UPPER WESTSIDE

RFQ 2025-01

Submitted Question Responses

Posted January 27, 2025

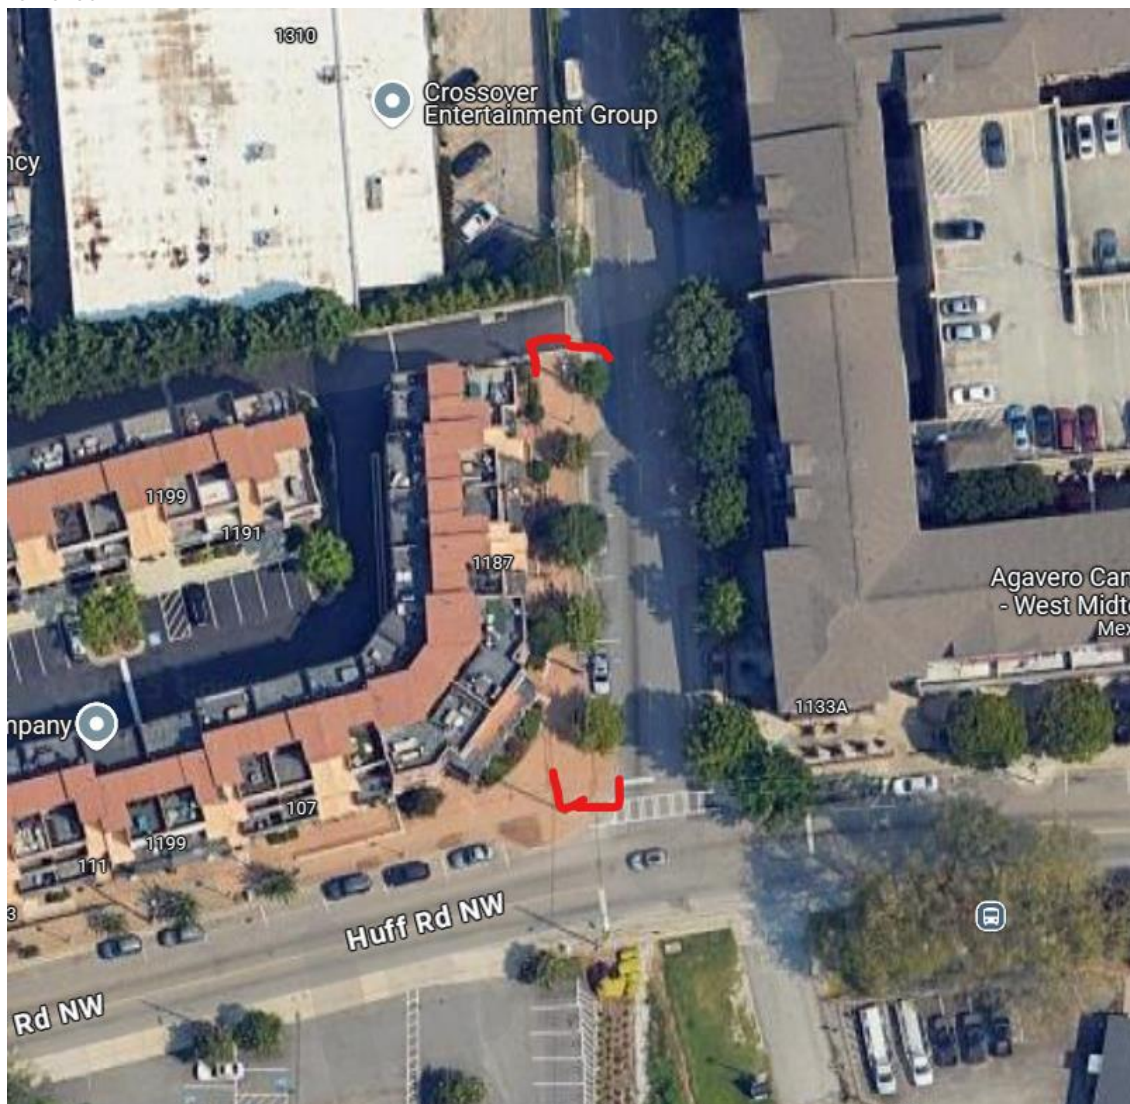
1. Will the CID please clarify which of the existing sidewalks along the corridor will remain?
We anticipate the sidewalk below to remain but it may need to be modified across the driveway. At this time, we expect for all other sidewalk on the west side of the street between Huff Road and Elaine Ave to be removed.

On the east side of the street, all existing sidewalks are currently expected to remain, but curb bulbouts, utility conflicts, and on-street parking may be re-evaluated during design.
